S E R V I C E N O T E

87510A Gain-Phase Analyzer

Modification prevents the 87510A from hanging up or generating an unexpected reset**To Be Performed By:** Agilent-Qualified Personnel**Parts Required:**

Figure 1. A1 Board Parts Location

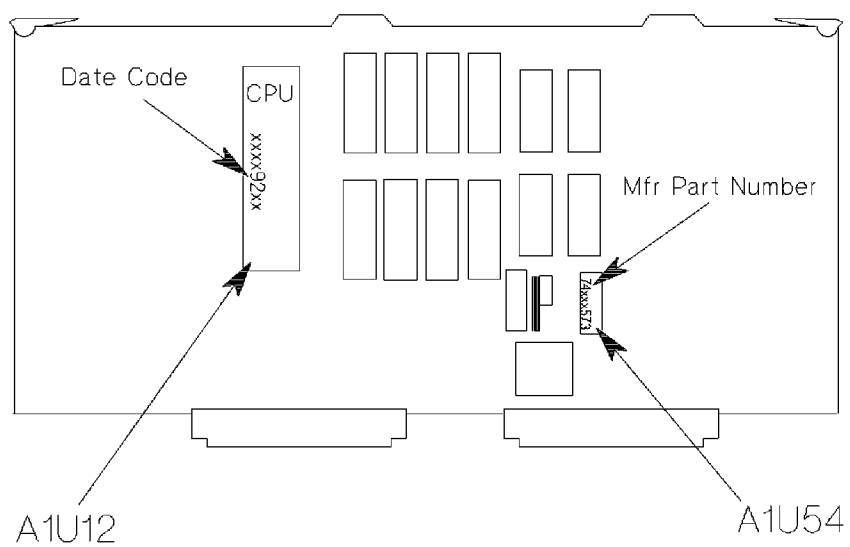
If the Date Code of the A1U12 is "92xx" and the Mfr Part Number of the A1U54 is "74F573" or "74BCT573", the address error may occur, which hangs up the 87510A or generates an unexpected reset.

1. Disconnect the power cable from the 87510A.
2. Remove the top cover and the shield plate from the 87510A.
3. Remove the A1 board from the 87510A.
4. Check the Date Code of the A1U12 and the Mfr Part Number of the A1U54.
(The Date Code and the Mfr Part Number are printed on each part. See Figure 1.)

If the Date Code of the A1U12 is “92xx” and the Mfr Part Number of the A1U54 is “74F573” or “74BCT573”, proceed to the next step.

Replace the A1U54 with the new one (Mfr Part Number: 74ABT573, Part Number: 1820-8885).

5. Remove the old A1U54 (Mfr Part Number: 74F573 or 74BCT573).

6. Install the new A1U54 (Mfr Part Number: 74ABT573, Part Number 1820-8885)
7. Reinstall the A1 board in the 87510A.
8. Turn the 87510A ON and confirm the “POWER ON TEST FAILED” message is NOT displayed.
9. Turn the 87510A OFF.
10. Reinstall the shield plate and the top cover on the 87510A.
